## ORIGINATION FORM

### Proposed Revisions to a Standard Plans Index (Please provide all information — Incomplete forms will be returned)

Index Number: 700-090

Index Title: Dynamic Message Sign Walk-In

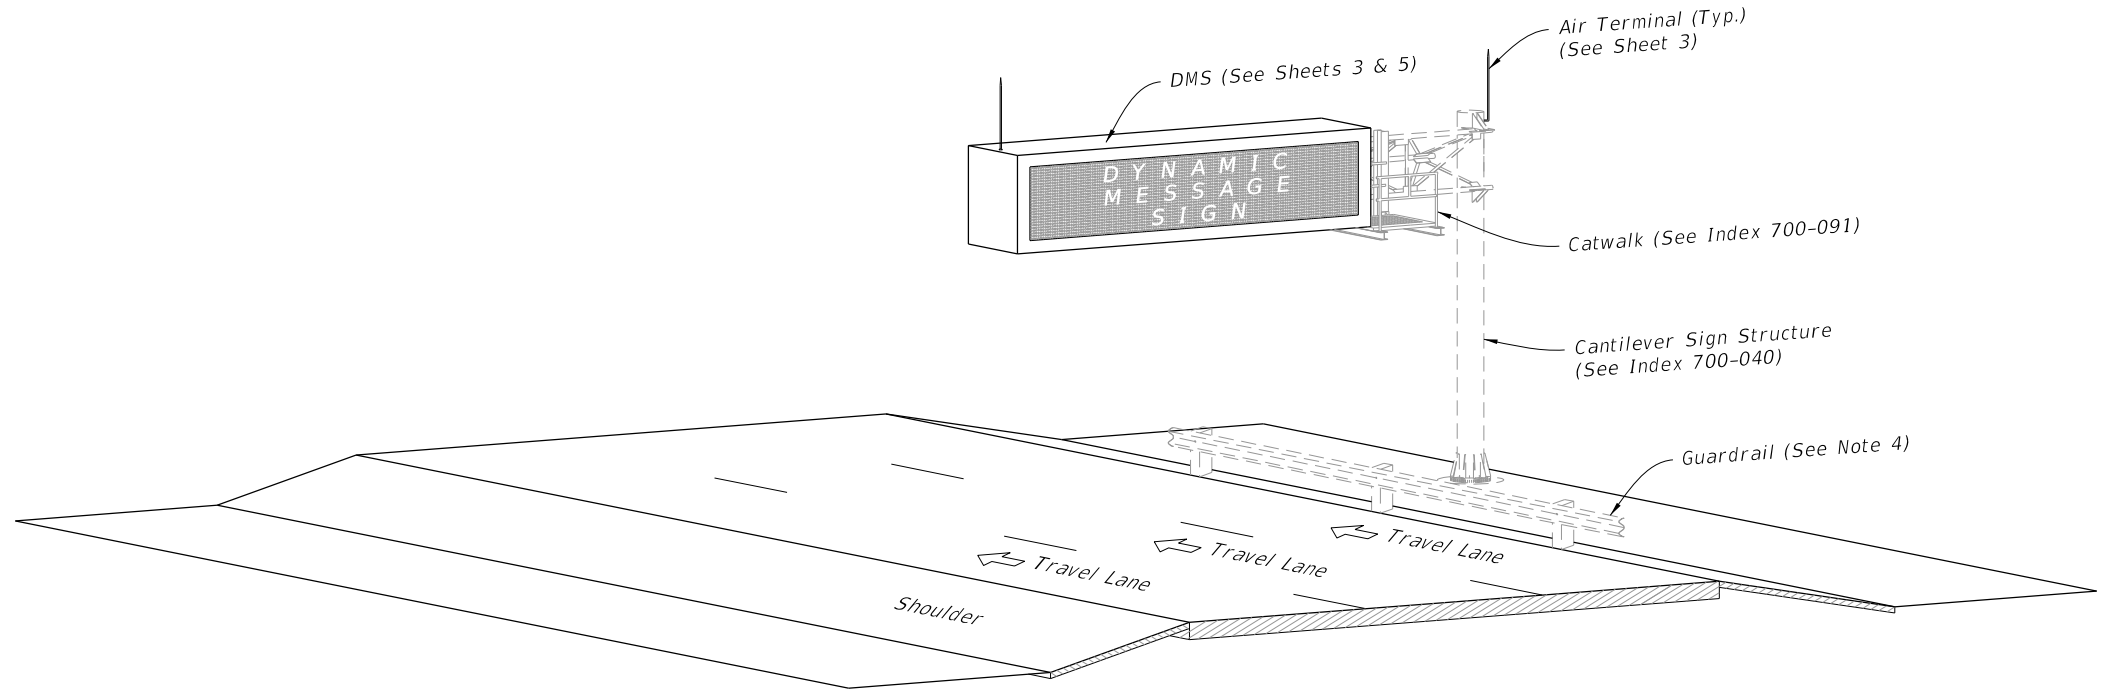
Sheet 1: Change Note 5.A.a reference to ASTM B308 to ASTM B221 throughout Standard Plans as an administrative change.

ASTM withdrew B308-10 so need to change it to ASTM B221 in all applications.

B221

**DETAIL "E"**

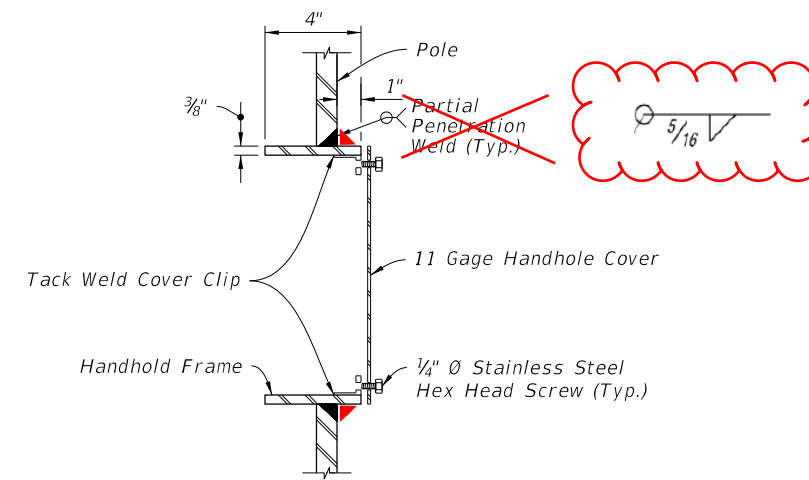
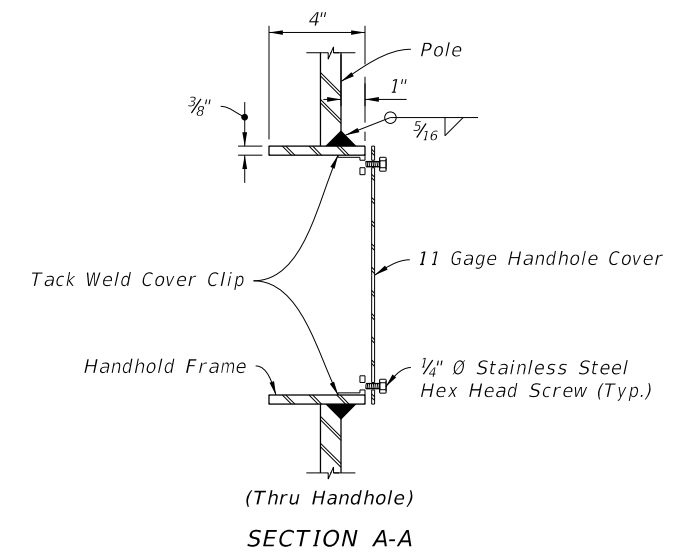
Sheet 4: Detail 'E' changed weld.

Change weld to meet current criteria as requested by industry.
